EC16-035

INFINITI; DTC P0456 CAUSED BY EVAP LEAK AT VENT CONTROL VALVE O-RING

APPLIED VEHICLES: 2017-2018 QX30 (H15)
2014-2017 QX50 (J50)
2016-2017 QX60 and QX60 Hybrid (L50)

Figure 7

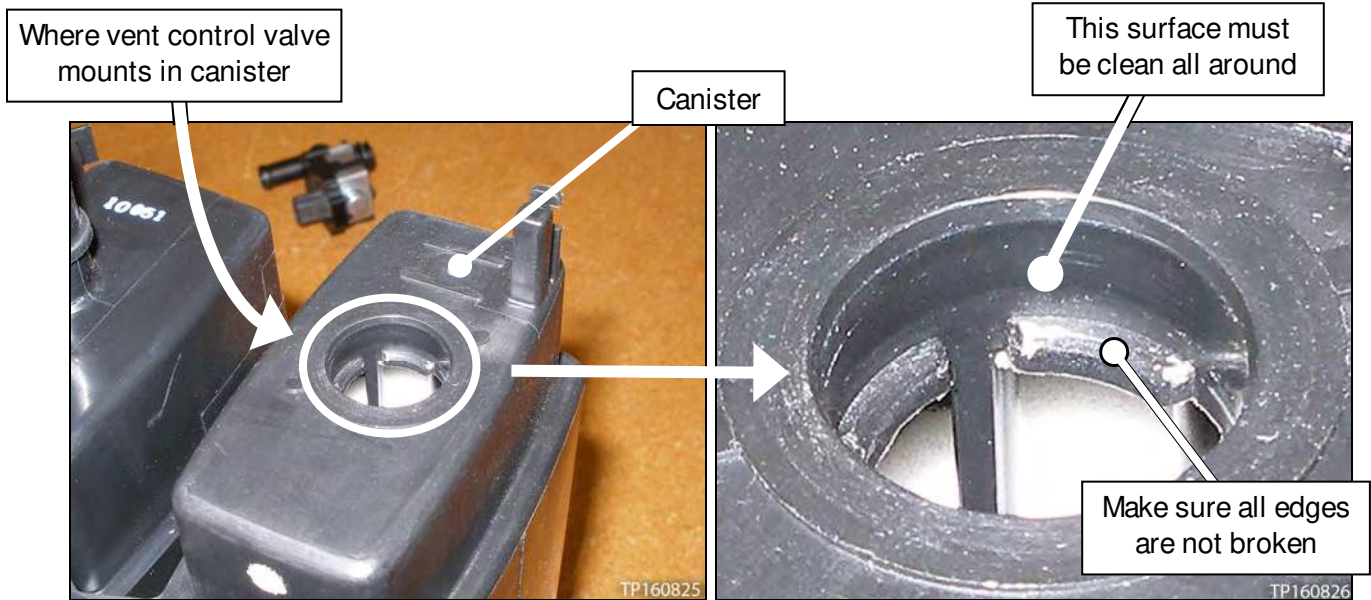
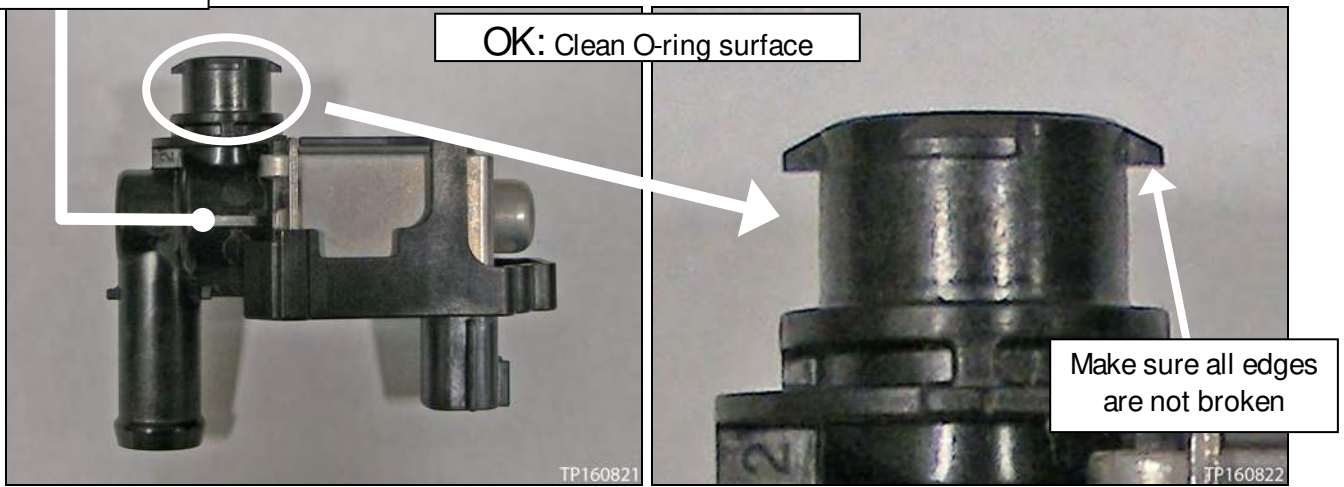
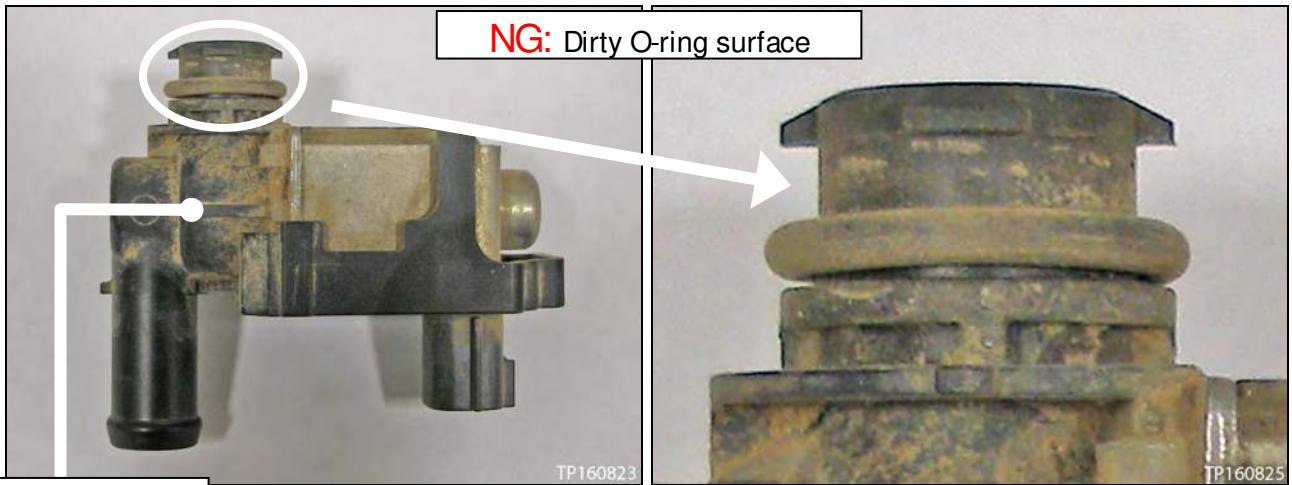
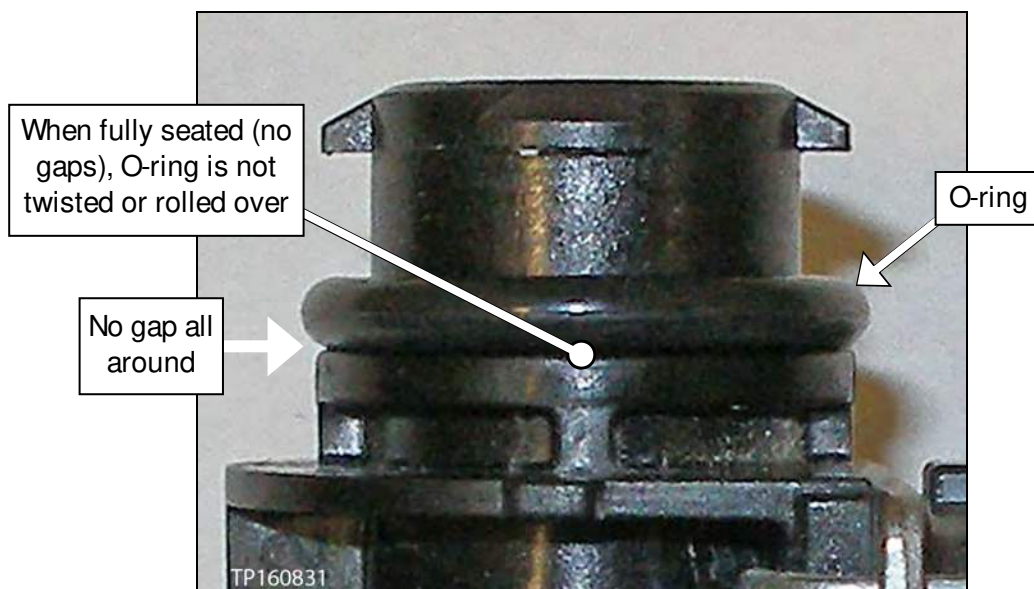
- To access the O-ring, refer to the appropriate section in the Electronic Service Manual (ESM) of the APPLIED VEHICLE for vent control valve removal and installation.
- This O-ring is now available separately (see PARTS INFORMATION).
- When installing, do not add any lubrication to the O-ring.
- Seat the O-ring all the way down as shown on page 4, Figure 7.
 - Having the O-ring seated all the way down will assure it is not twisted or rolled over.
- Refer to the pictures on pages 3 and 4 for additional installation information.

- Make sure the surfaces that the O-ring comes in contact with are clean.
- When installed, make sure the O-ring is not twisted or rolled over.
- Verify the repair is complete by checking for leaks with a “smoke” leak detection machine or CONSULT-III plus (C-III plus).
 - If a “smoke” leak detection machine is used, follow the manufacturer’s operating instructions.
 - If C-III plus is used:
 1. Confirm the fuel filler cap is secure.
 2. Connect Essential Tool J-42909 to the EVAP service port.
 3. Using Active Test, close the vent control valve.
 4. Apply pressure using J-42909 until the bar graph reaches about halfway.
 5. Monitor the bar graph for 10 minutes.

1. Replace the O-ring.
